ADDENDUM NO. 1

Project: **PARKS 2023-0001 – DSRP RANCH HOUSE ROAD PHASE 2**

Owner: **City of Dripping Springs, Texas**

Date: **May 12th, 2023**

Sheet 3 of 28 – SCHEDULE OF QUANTITIES

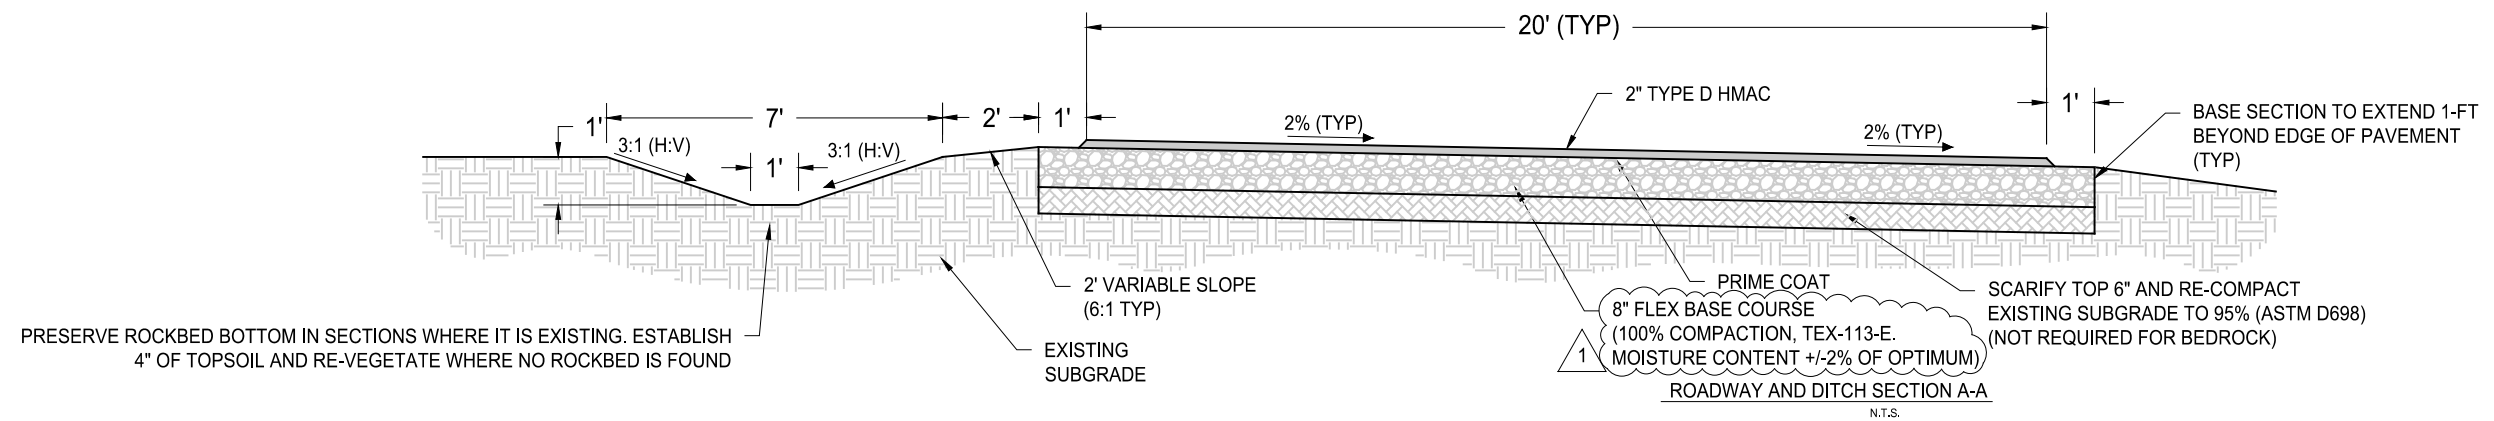
UPDATE – TxDOT Item 247 compaction and moisture content requirements.

TXDOT ITEM 247 - FLEXIBLE BASE
EACH COURSE OF BASE SHALL BE COMPACTED TO A MINIMUM DENSITY OF 100 PERCENT (100%), ACCORDING TO TXDOT TEST METHOD TEX-113-E, WITH A MOISTURE CONTENT OF +/- 2% OF OPTIMUM.

Sheet 11 of 28 – TYPICAL SECTIONS

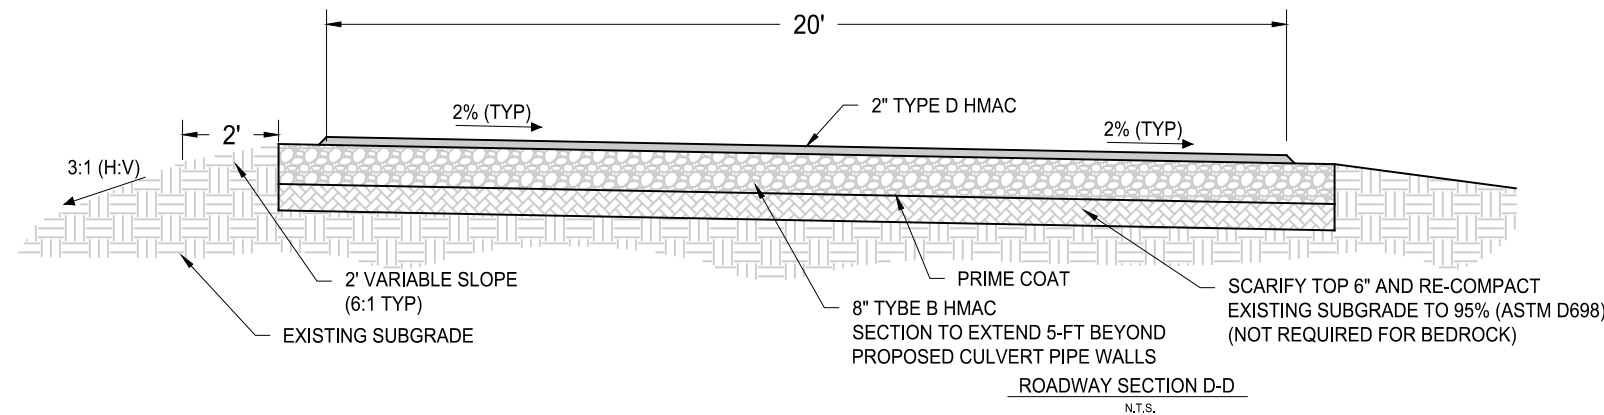
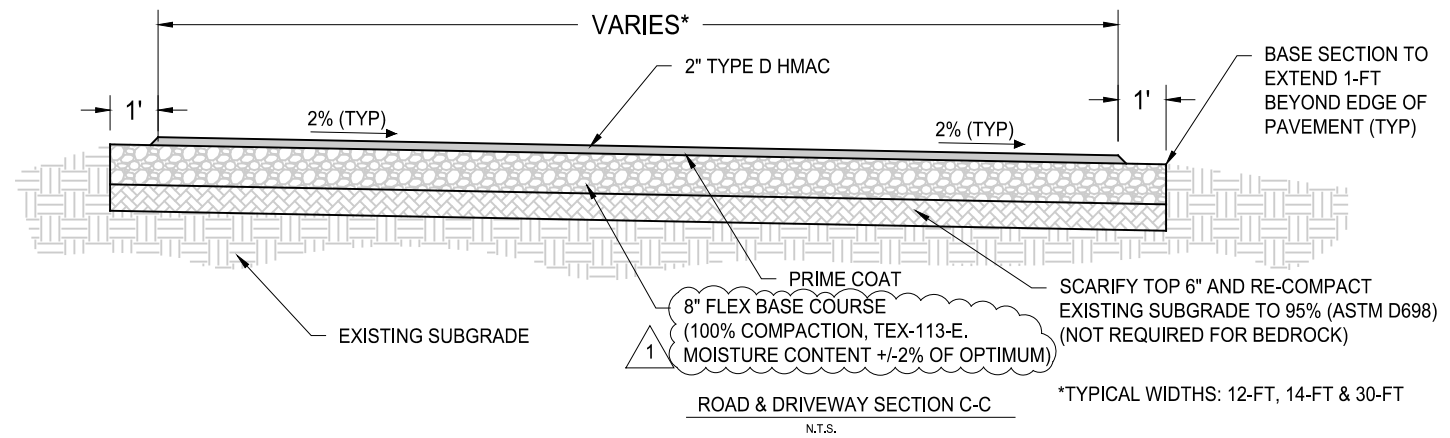
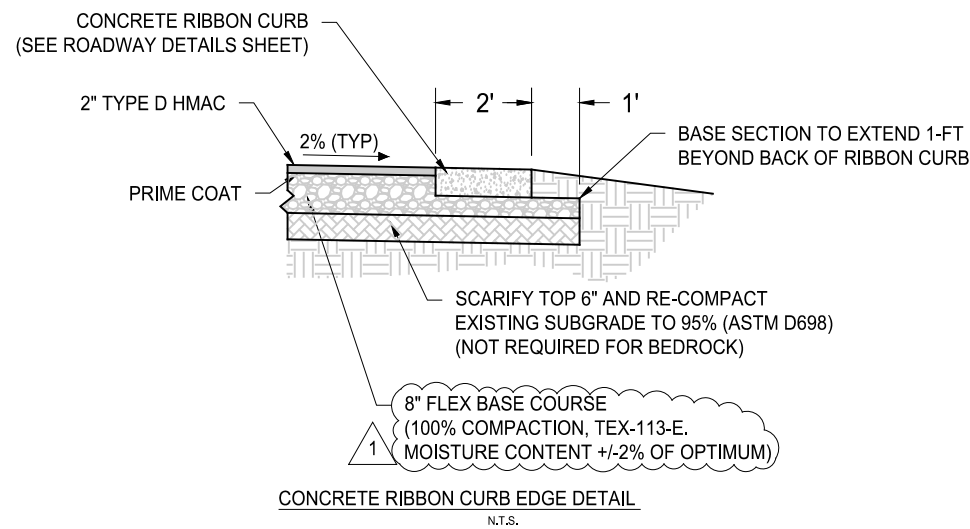
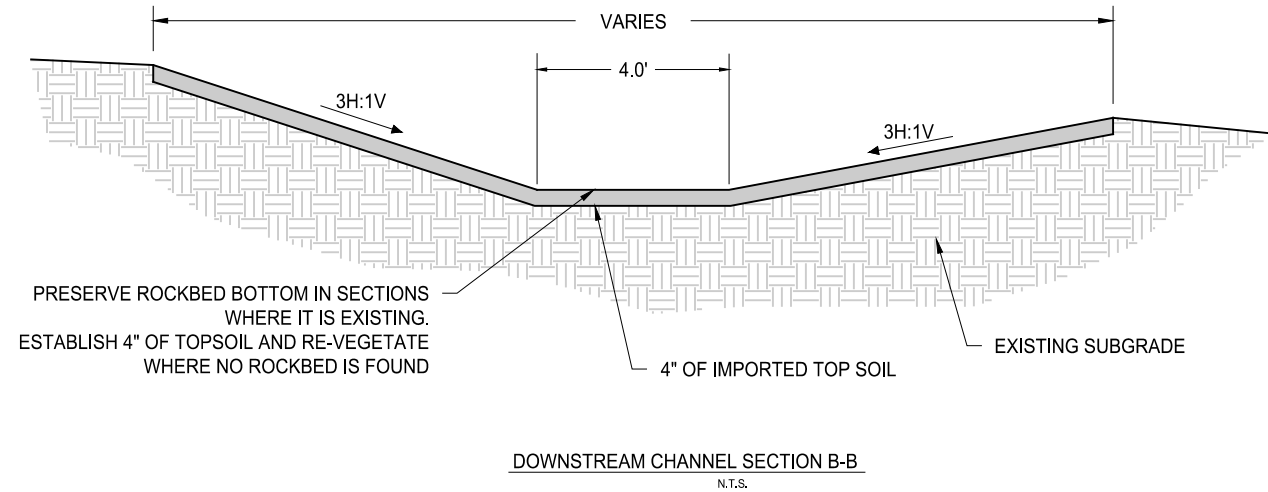
UPDATE – Flex Base compaction and moisture content requirements.

- a. *Clarification:* Each course of base shall be compacted to a minimum density of 100 percent (100%), according to TxDOT Test Method TEX-113-E, with a moisture content +/-2% of optimum.
